PLOT PLAN

○ NEVADA LANE
COLORADO SPRINGS, COLORADO

Markup Summary

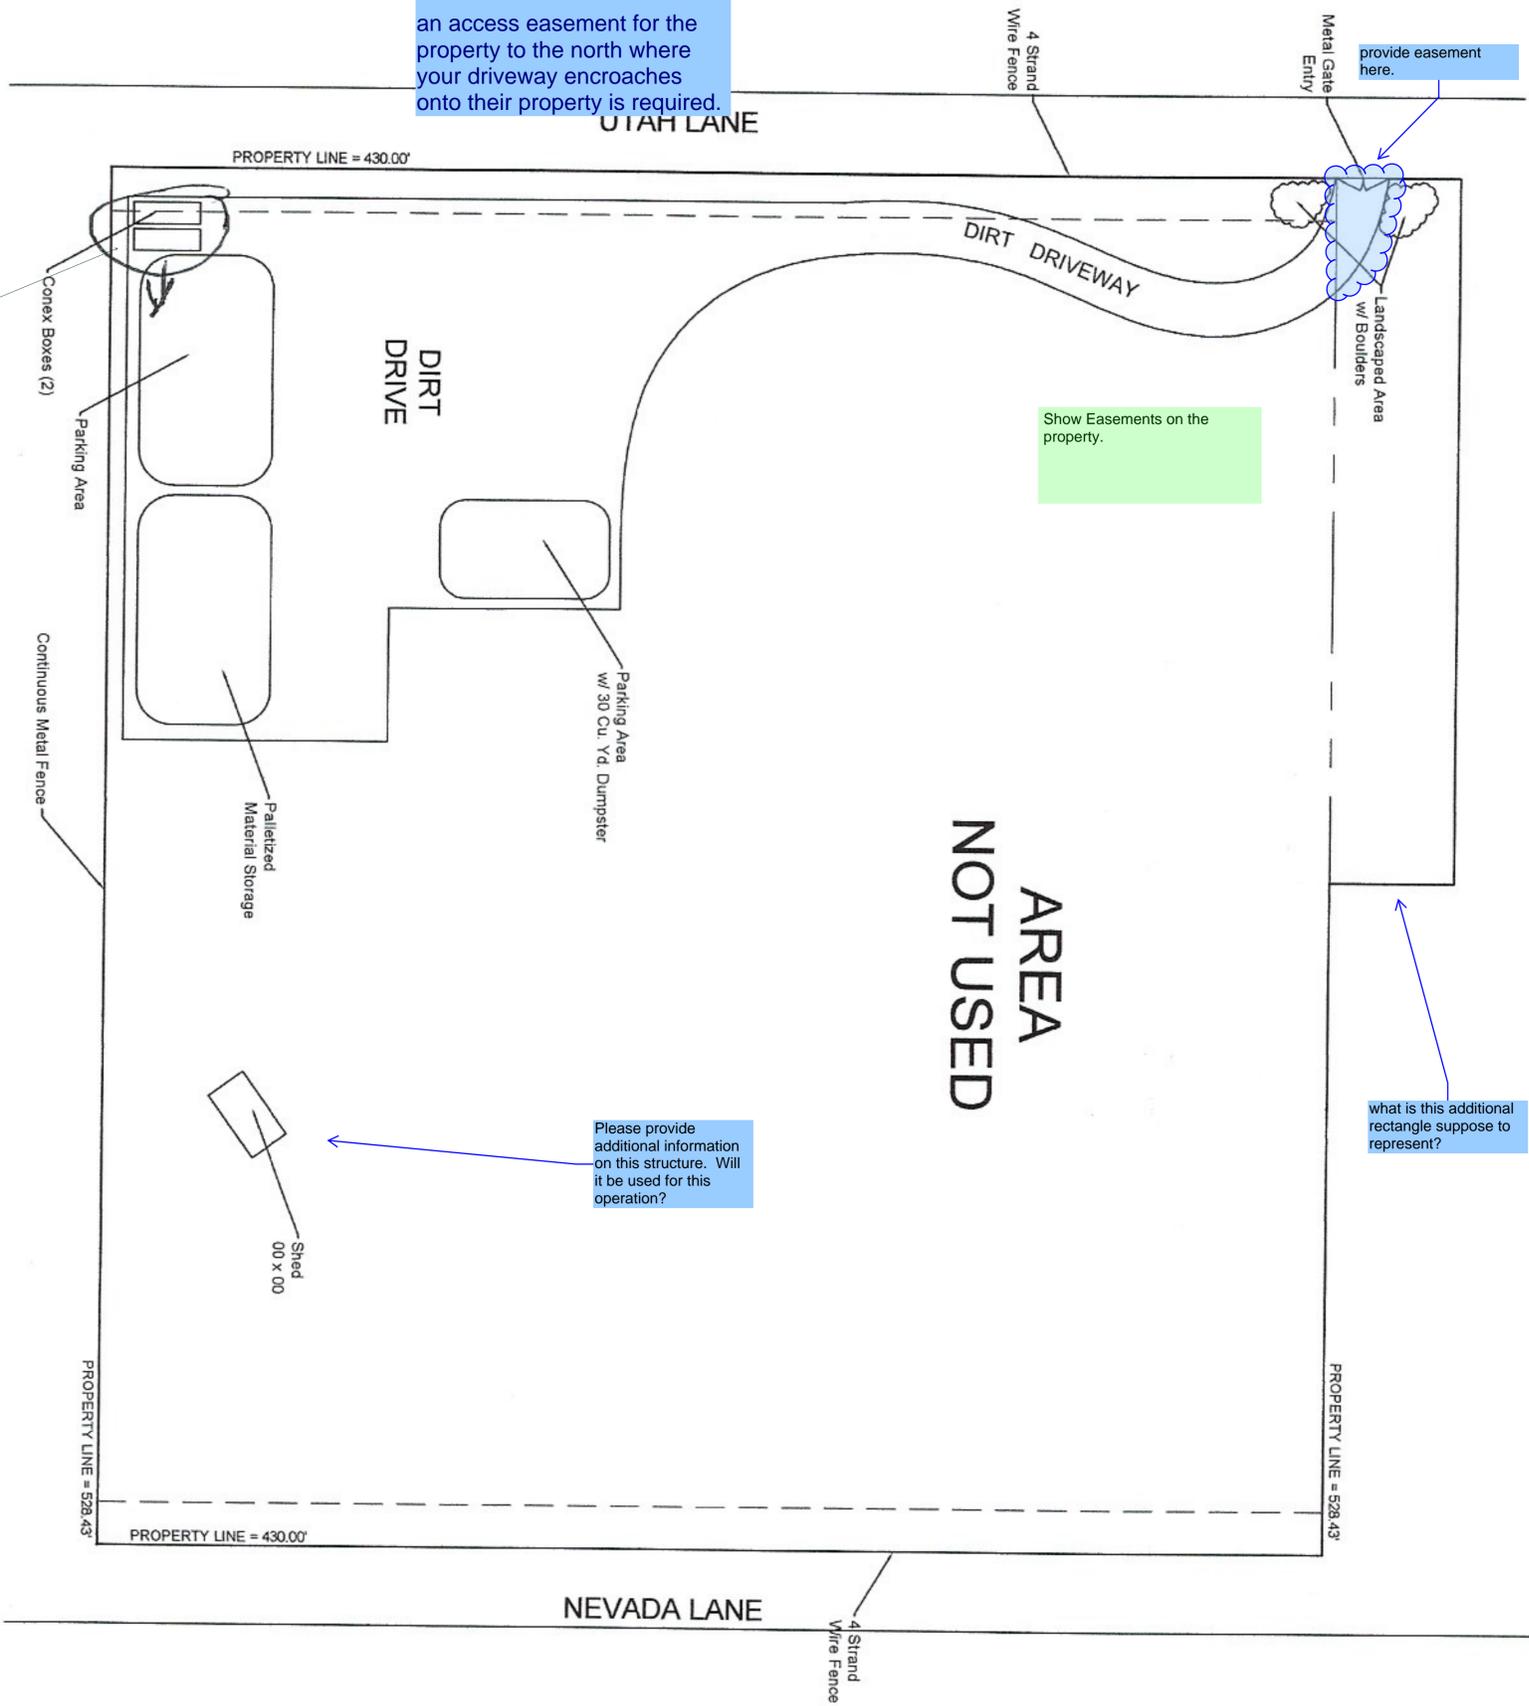
According to the El Paso County Assessors office this parcel is rectangle as well as "TOG Nevada Lane". Please correct your site plan to reflect the addition of Nevada Lane as a part of your property. Please show/include all easements

Please call out all adjacent property owners, as can be found on the El Paso County Assessors page.

an access easement for the property to the north where your driveway encroaches onto their property is required.

provide easement here.

Show Easements on the property.

what is this additional rectangle suppose to represent?

Please provide additional information on this structure. Will it be used for this operation?

Show 25 foot building setback (structures included in this i.e. connex's) around the entire property.
